Master Plan Amendment #2015-0003
Rezoning#2015-0003
Development Special Use Permit #2014-0035
Transportation Management Plan SUP #2015-0081
Ramsey Homes Redevelopment

Staff Recommendation: APPROVAL WITH CONDITIONS

PLANNING COMMISSION ACTION, FEBRAURY 4, 2016:

Master Plan Amendment #2015-0003
Rezoning #2015-0003
Development Special Use Permit #2014-0035
Transportation Management Plan SUP #2015-0081
699 North Patrick Street

Proposed Site Plan

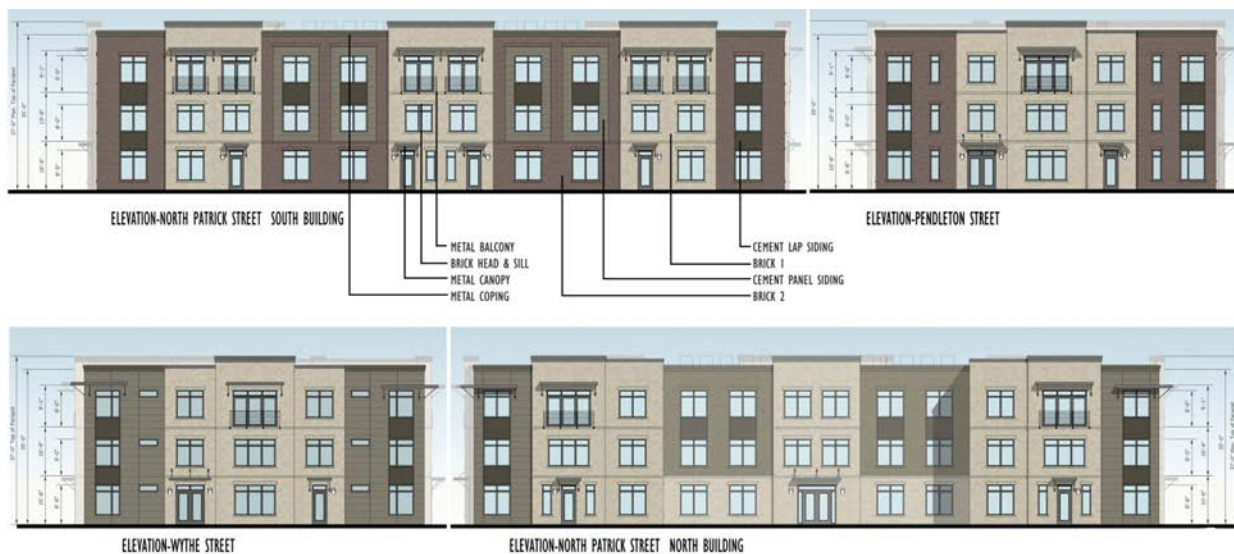
1. The Final Site shall be in substantial conformance with the preliminary plan dated August 21 as updated to December 18, 2015 and comply with the following conditions of approval.

3. Provide a total of 40% open space on-site in conformance with the CRMU-M zone. This open space may be provided in a combination of at grade open space and rooftop amenity space accessible for use and enjoyment of the residents. (P&Z)

7. Develop a design for the rooftop open spaces to include both active and passive amenities. At a minimum, both rooftop amenity spaces should include shade features, seating areas, and space for vegetation, and recreational opportunities for children should be located on the north building rooftop. The rooftop area next to townhouses on Pendleton Street should be designed for less active and quieter uses. Provide a palette of materials, details and specifications for all associated features. *(P&Z)(PC)

- b. The north building shall have a central door entry in the courtyard facing N. Patrick Street. Update the interior floor plans and landscape plans to reflect the central entrance.
